PLANNING COMMISSION AGENDA REPORT

SUBJECT: 1381 CALLE JOAQUIN (ARCH-0783-2021) REVIEW OF A NEW 30,986 SQUARE FOOT AUTO DEALERSHIP AND SIGN PROGRAM, WITH A REQUEST FOR A FENCE HEIGHT EXCEPTION

ARCH-0783-2021

Planning Commission Report – May 25, 2022

Figure 4: Comparison of the previous and revised north elevation

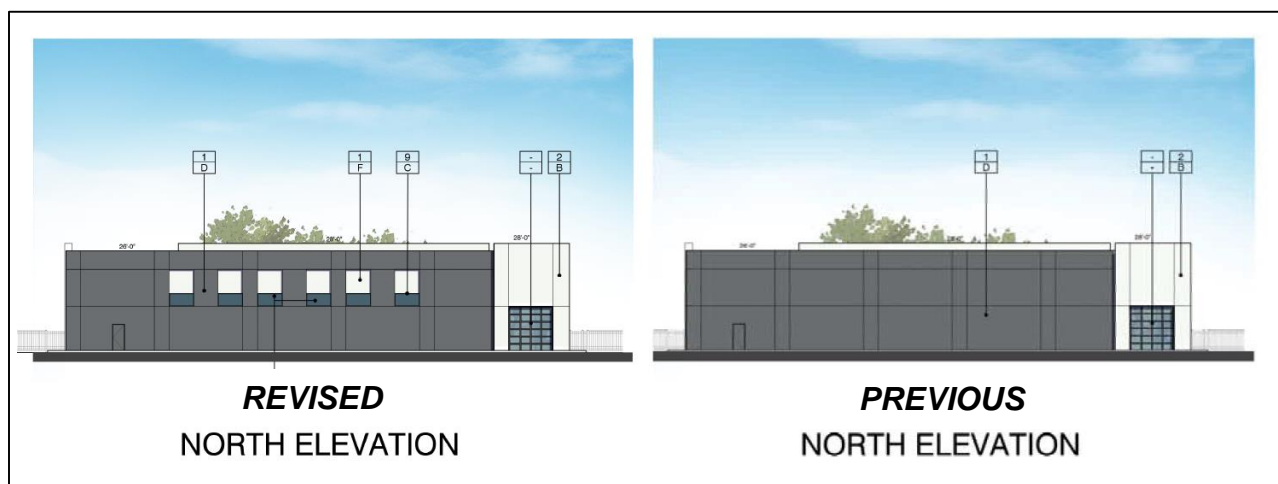
ARC Direction: The applicant should include additional articulation along the auto dealership's exterior north elevation through the use of colors, materials, and/or windows to be consistent with CDG guidance on four-sided architecture.

Response: Per ARC's direction, the applicant has provided revised elevations that show the addition of windows on the north elevation (see Figure 4). Staff finds that the revised elevation is consistent with ARC direction and recommends Condition of Approval No. 2 to ensure that plans submitted for a building permit include windows as proposed, subject to the approval of the Community Development Director.
